Subject: Response to Request for Additional Information (RAI) Letter No. 7 –  
Exelon Early Site Permit (ESP) Application for the Clinton ESP Site  
(TAC No. MC1122)

Re: Letter, U.S. Nuclear Regulatory Commission (N. V. Gilles) to Exelon  
Generation Company, LLC, (M. Kray), dated July 26, 2004, Request for  
Additional Information Letter No. 7 – Exelon Early Site Permit  
Application for the Clinton ESP Site (TAC No. MC1122)

**NRC Letter Dated: 07/26/2004**

Figure 2.5.1-1-1 Median and Mean Seismic Hazard Curves for 1-Hz Spectral Acceleration Developed Using Alternative Distributions for Characteristic New Madrid Earthquakes

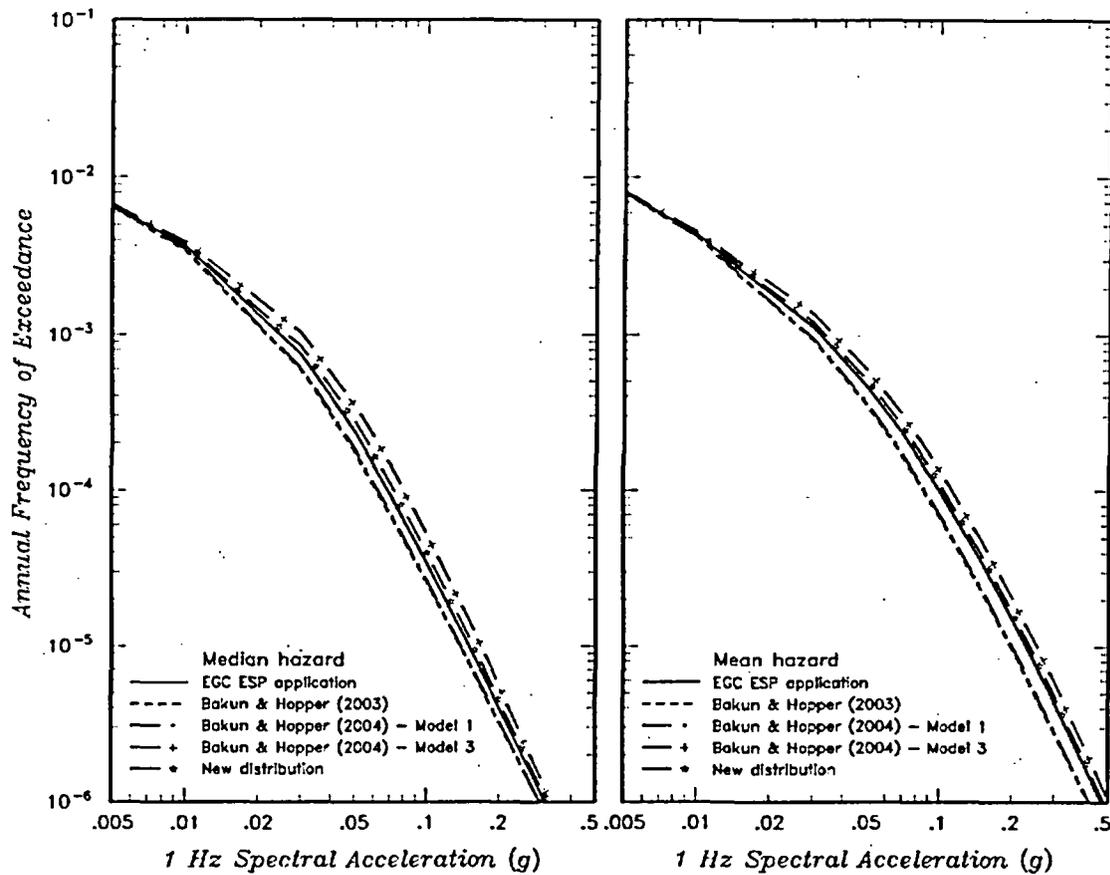
In characterizing the seismic hazard of the New Madrid seismic source zone, SSAR Appendix B (Sections 2.1.5.2.1, 4.1.1.2, and Tables 2.1-3 and 4.1-1) cites the preferred magnitudes of Bakun and Hooper (2003, in press) for the New Madrid main shocks of 1811-12 as M 7.2, 7.1, and 7.4. The work of Bakun and Hooper (2003, in press) has since been revised with magnitude estimates for the 1811-12 New Madrid main shocks as M 7.6, 7.5, and 7.8 (Bakun and Hooper, 2004, Bull. Seism. Soc. Am., v. 94, no. 1, p. 64-75). Please explain what changes these revised magnitude estimates may require in the weights listed in Table 4.1-2 for the size of the expected characteristic earthquake rupture for each fault within the New Madrid seismic zone. In addition, please quantify the effect of the revised magnitude estimates on the hazard at the site by providing a graph showing two long-period (1 Hz) hazard curves, one using the magnitudes of Bakun and Hooper (2003, in press) and the second one using the magnitudes of Bakun and Hooper (2004).

The results of the requested sensitivity analyses to test the impact of different characteristic magnitude assessments on the median and mean rock hazard for 1 Hz spectral acceleration at the EGC ESP Site are shown in Figure 2.5.1-1-1. Five hazard curves are shown on each plot. The curves labeled "EGC ESP application" are taken from Appendix B of the EGC ESP Application. The curves labeled "Bakun & Hopper (2003, in press)," "Bakun & Hopper (2004) - Model 1," and "Bakun & Hopper (2004) - Model 3" were computed using only the indicated magnitude estimates for each of the New Madrid faults. The curves labeled "New distribution" were computed using the suggested updated distribution given in Table 2.5.1-1-2. The new distribution produces approximately 3 to 4 percent higher ground motions at the mean  $10^{-4}$  and mean  $10^{-5}$  hazard levels. These results were computed using the recurrence model and rupture sequences developed in the EGC ESP Application. The effects of alternative recurrence estimates and rupture sequences are presented in the response to RAI 2.5.2-5.
